Re: Submission for [REDACTED] Riverstone, as advertised in the Draft Riverstone East Precinct Plan

This submission focuses on two key elements proposed for the site.
The road layout within the ILP, and the Height of Buildings control within the Growth Centres SEPP.

RIVERSTONE EAST PRECINCT
DRAFT INDICATIVE LAYOUT PLAN

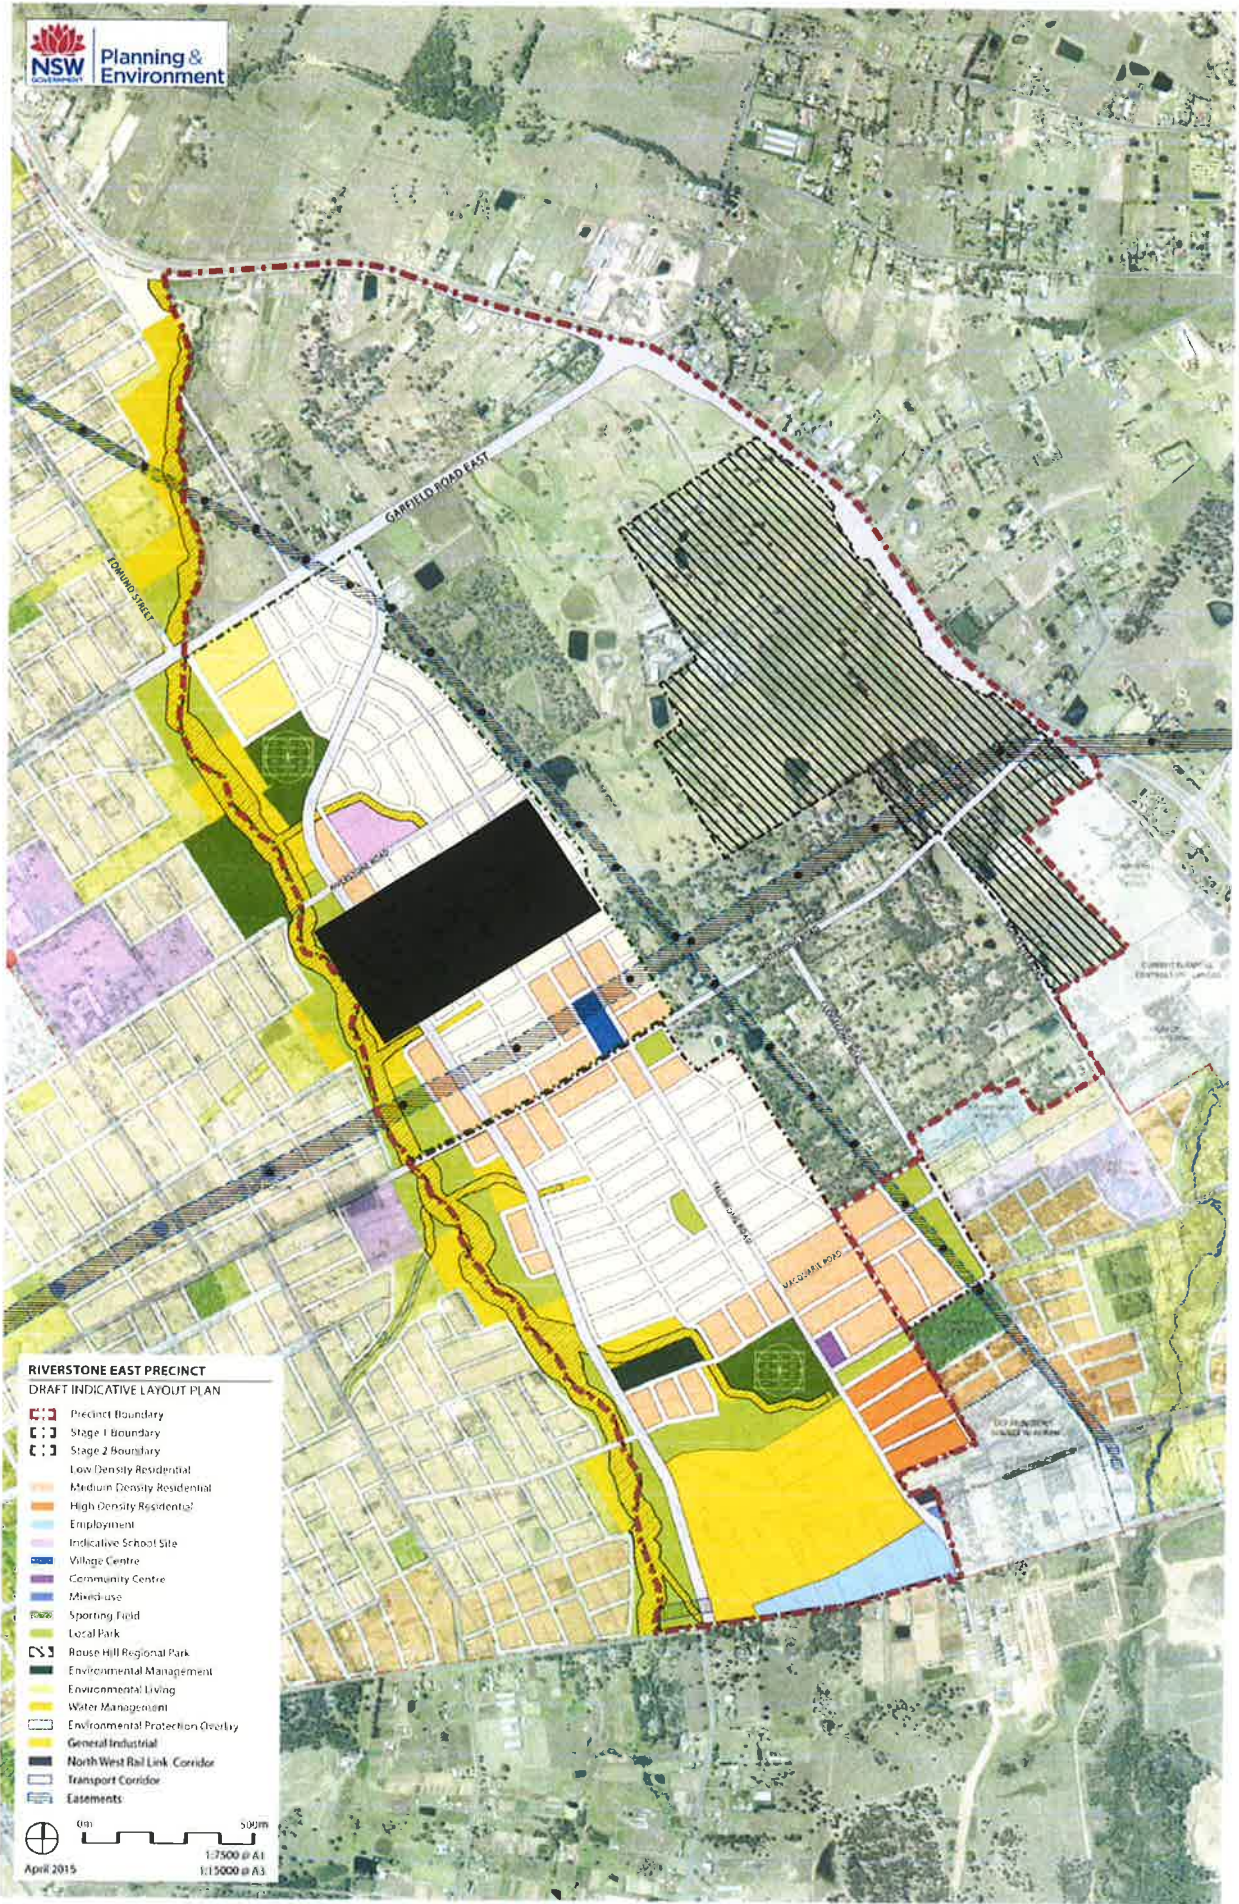
The Draft ILP shows the site to have a 3 street frontage, as well as a road proposed through the centre of the property. (See Attachment 1 of the Draft ILP for the location of the property)

It is acknowledged that the removal of the centre road from the site requires careful consideration of the associated traffic impacts. Therefore by removing the proposed intersecting centre road it will eliminate further disturbance to Clarke Street, (given that it serves no practical purpose) as well as providing a much better site layout for future developments, allowing potential to provide a scheme that achieves a more desirable outcome for residents and the surrounding public, particularly with better traffic flow on

Clarke Street. An amendment to the ILP is therefore recommended to remove the intersecting centre street from the subject site (See Attachment 2).
